Designation: **C719–14 (Reapproved 2019) C719 – 22**

Standard Test Method for Adhesion and Cohesion of Elastomeric Joint Sealants Under Cyclic Movement (Hockman Cycle)^{1,2}

FIG. 1 Compression-Extension Machine

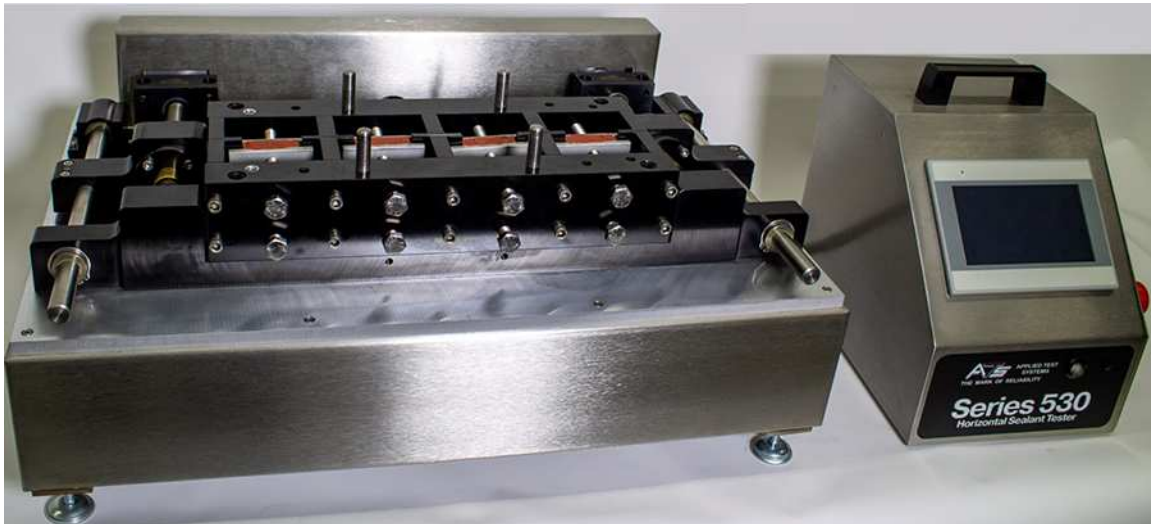
6.1 *Compression-Extension Machine*,⁵ designed to automatically compress the joint width of the test specimen from 0.500 in. (12.7 mm) to the minimum dimension desired (Table 1, Column C) and extend the specimen from 0.500 in. to the maximum extension desired (Table 1, Column E) at a constant rate of 1/8 in./h (3.2 mm/h). The machine shall be equipped with grips of sufficient strength to withstand, without bending, the resistance of high tensile strength sealants (see ~~Figs. 1-3~~ Fig. 1) and Fig. 2).

⁵ Series 520-510, 530 (previously 520), and 540 Sealing Compound Tester, Testers, manufactured by Applied Test Systems Inc., 348 New Castle Rd., Butler, PA 16001, and a durability tester manufactured by Amgard, Inc., 269-11 81st Ave., New Hyde Park, NY 11040, Systems, <https://www.atspa.com/>, have been found suitable for this purpose (Fig. 1 (purpose, Series 530a)). For extension of the joint at cold temperature, the machine may be designed for extension only (Fig. 3); is shown in Figs 1 and 2.

FIG. 2 Compression-Extension Machine with Control Unit

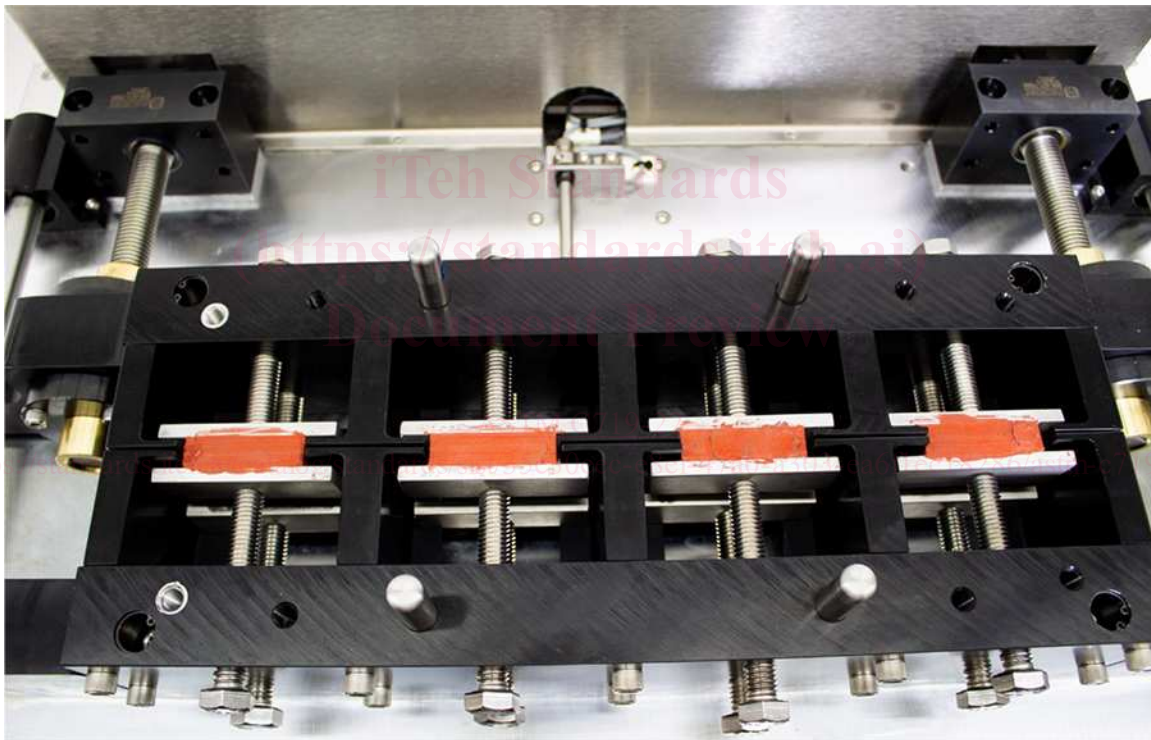
FIG. 32 Top View of Machine in Fig. 21 Showing ThreeEight Specimens Ready for AutomatieAutomated Cycling

FIG. 53 Test Specimen for Glass 25 and Class 12.5 Sealants Configuration Examples

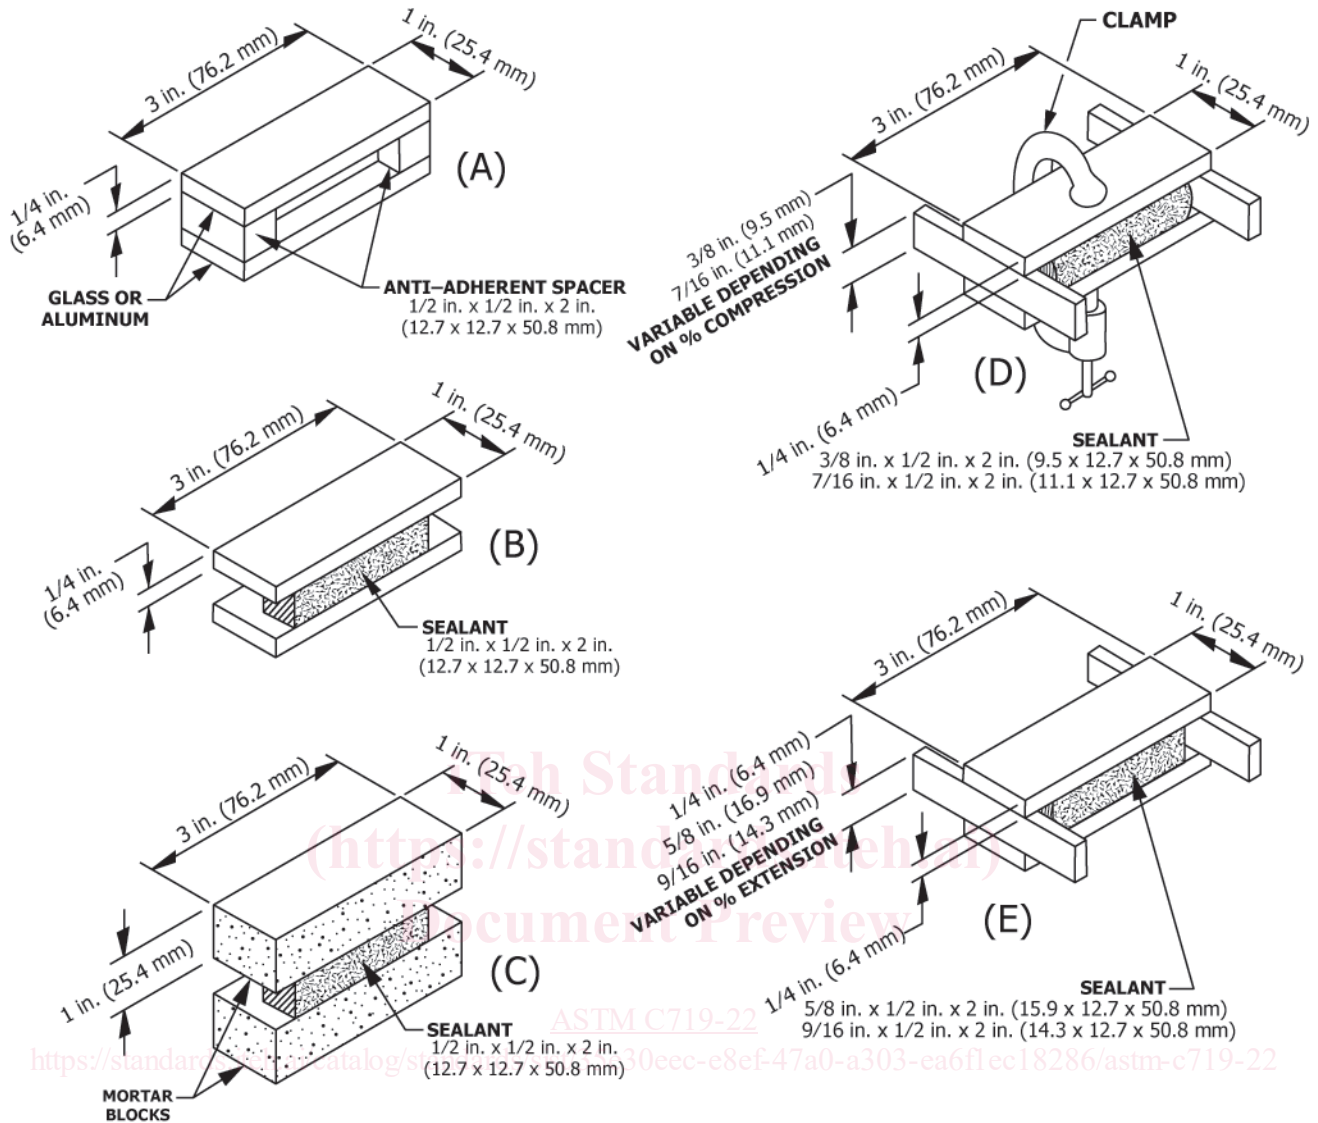
- (a) Prepared specimen before placement of sealant, (b) Sealant Specimen with casting spacers removed, (c) Sealant between Specimen made with mortar blocks, (d) Sealant Specimen in the compressed state during heat treatment, (e) Sealant Specimen in the extended state.

FIG. 64 Oven Compression Apparatus

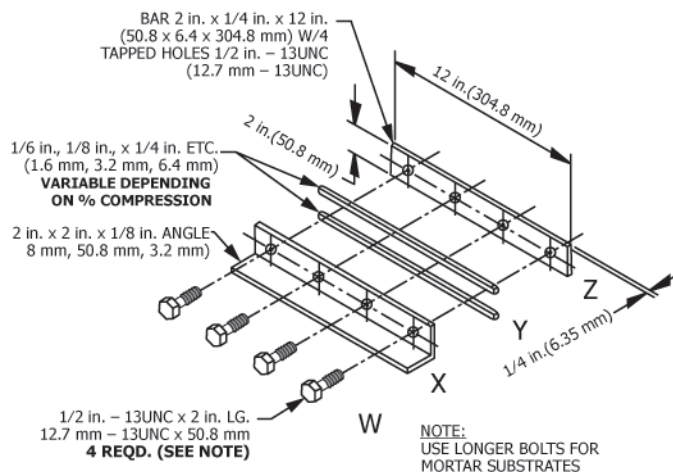
NOTE 1—Use longer screwbolts for concrete substrate.
